**ANNEX D**  
**Sediment Transport and Geomorphology**

**TECHNICAL REVIEW REPORT**

**Prior Consultation for the Proposed Luang Prabang  
Hydropower Project**

**Prepared by:**  
Mekong River Commission Secretariat

Figure 1. (Left) Discharge graph for the LLO in the FS (right) Discharge graph for the LLO based on the data in Table 5-Discharge rating of Luang Prabang HPP Low-level outlets (SS gates closed).

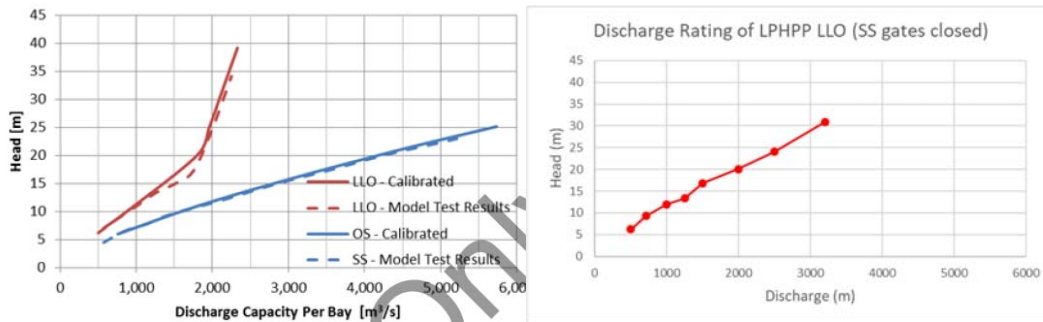
- The relationship between the LLO discharge graph presented in the FS and the hydraulic data provided in the Hydraulic Model Test Report is not well explained. All discharge information related to the spillway is based on adjusting the Xayaburi physical test work results to the conditions at Luang Prabang (e.g. reducing the number of bays). The graph in the FS shows a distinct change in discharge as compared to Head at approximately 20 m head and  $\sim 1,800 \text{ m}^3\text{s}^{-1}$  (Figure 1), whereas the data presented in the Hydraulic Modelling report shows a linear relationship. The results presented in the FS are based on the fully open LLO and surface spillways, whereas the results presented in the Hydraulic Model report are for the LLO operating in isolation. This accounts for the difference between the graphs, but raises questions about the combined operations of the gates. The target discharge for opening the surface spillway gates in addition to the bottom gates is not discussed with respect to sediment transport through the LLO. The test work upon which the results presented in the FS are based does not appear to be included in the Hydraulic report. A more complete explanation of the model, its set-up and calibration and how the results will be translated into operating rules for the the LPHPP is warranted;

Figure 2. Modelling results from Feasibility study showing smoothed bottom topography and distribution of sediment deposition. Pöyry, 2019.

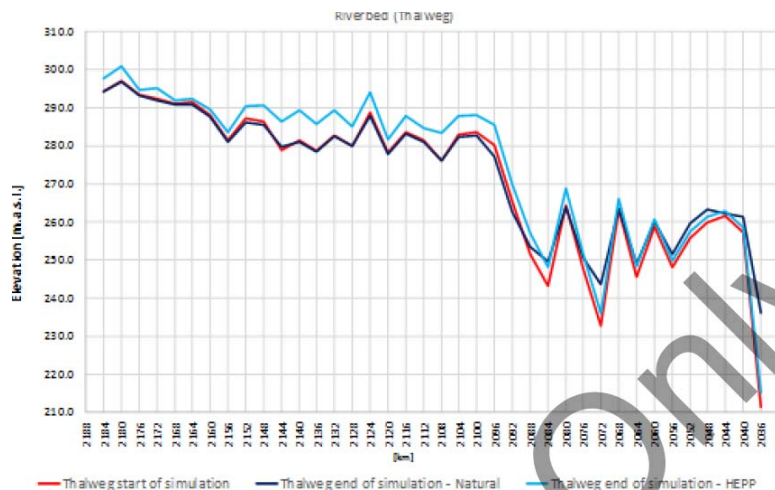
- The GSTAR model is a basic 1-D model sediment transport model. Flows are averaged across the cross section, eliminating the potential for the model to predict preferential deposition in quiescent areas in otherwise fast flowing cross-sections. The FS recognises this and states that the model should be considered a 'rough estimate of the sediment transport processes'. Understanding sediment transport is a significant transboundary issue and a more robust modelling approach should be applied to provide the MCs with the most reliable information possible. More details regarding the setup and calibration of the model should be provided to the MCs for transparency;

- The longitudinal section used for the sediment transport model is based on 38 cross-sections and parameters used for Xayaburi but has not been calibrated for Luang Prabang. The longitudinal section used shows a relatively flat area in the upper section of the impoundment and a large change in elevation between km 2100 and km 2080 (Figure 2). The more detailed longitudinal section collected for the LPHPP FS captures the high frequency of deep pools within the impoundment, and shows a more continuous slope as compared to the model setup (Figure 3). These differences will affect the results, including a likely under estimation of the trapping efficiency by deep pools;

Figure 3. Bathymetry of the proposed LPHPP impoundment from the dam site to 140 km upstream showing high frequency of deep pools. Source Pöyry, 2019. Note that the x axis is incorrectly labelled as kilometres.

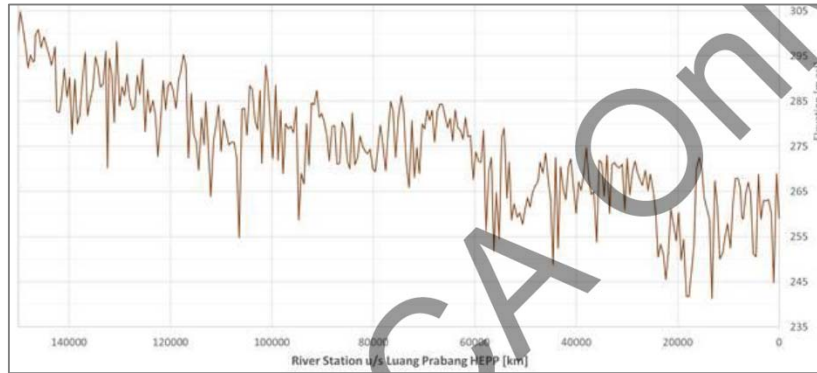
- The text states that Figure 12-5 shows the natural condition and impounded condition, but all data sets appear to reflect the impounded river at different flow rates. Including the natural state would be useful for understanding how the depth of the impoundment changes with distance upstream. The scale in Figure 12-5 indicates km and ranges from 0 to 140,000, suggesting the scale should be in metres;

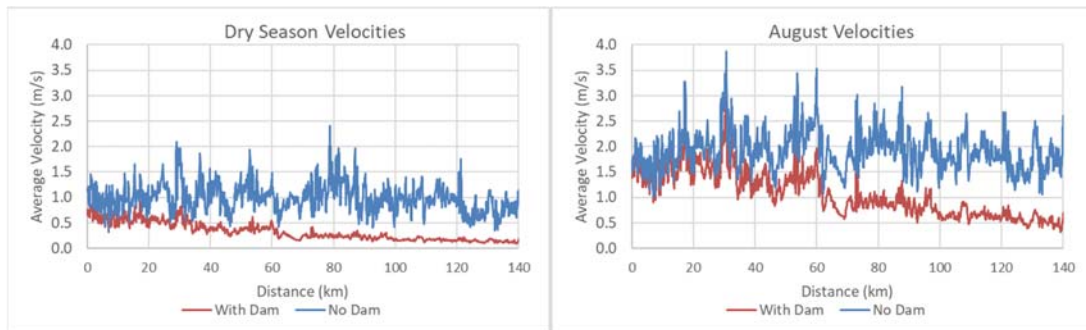
In general, the modelling results are consistent with water velocity results from the MRC ISH 0306 Case Study (MRC, 2017) that examined sediment transport through the Luang Prabang impoundment using the Delft 3D model as part of modelling the entire Upper Lao PDR cascade (Figure 4). The velocity results show a substantial reduction in velocity with distance downstream during both the dry and wet seasons, accounting for the lack of sediment transport downstream. The results highlight that in order to pass sediment through the impoundment either (1) a delta will need to form and prograde the entire length of the impoundment until it reaches the toe of the LLO and can be discharged using pressure flushing at high river flow, or (2) the operators will need to use sediment flushing to promote the movement of material downstream, thus lessening the time period before sediment can be released. The FS states that considerable periods will be required to establish a new sediment equilibrium, but there is no consideration of management actions such as sediment flushing that could reduce this time period, leading to a reduction in transboundary impacts;

Figure 5. Sediment modelling results of the Luang Prabang and Xayaburi impoundments showing erosion of the river bed at the upstream end of each impoundment. Scenarios do not include sediment flushing. Source: MRC (2016).

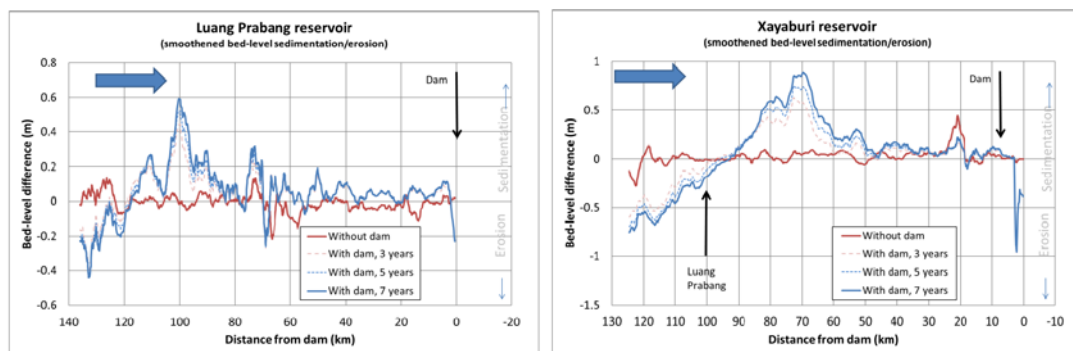
- The FS broadly discusses the interaction between the proposed LPHPP and upstream and downstream mainstream dams and the need for close cooperation regarding sediment flushing, spillway operation and fish migration but actual strategies based on cooperation are not presented. This is a very important issue and merits greater investigation and modelling effort, especially in the reach downstream of LPHPP and the backwater of Xayaburi where various processes could affect this reach. There is potential for increased deposition in this area unless water levels in Xayaburi are reduced to promote transport of the sediment downstream during periods when Luang Prabang or Nam Ou are discharging sediments. There is also potential for erosion in this reach due to sediment poor water being

discharged from both the LPHPP and Nam Ou depending on the extend of the Xayaburi backwater. This risk of erosion was demonstrated in the ISH0306 sediment modelling exercise, where channel erosion was predicted in the Xayaburi backwater due to upstream hydropower operations and sediment trapping (Figure 5). Erosion in the reach could induce channel instability and bank erosion. This is not a transboundary issue per se, however overall sediment management is a significant transboundary issue, with the efficient transport of sediments through the cascade critical for the maintenance of sediment delivery to the LMB downstream of the cascade. It is recommended that this reach be specifically investigated in future hydraulic and sediment transport modelling exercises, and that the operators of the Nam Ou cascade and Xayaburi HPP are consulted and included in developing the scenarios to reflect likely operations of each hydropower project.
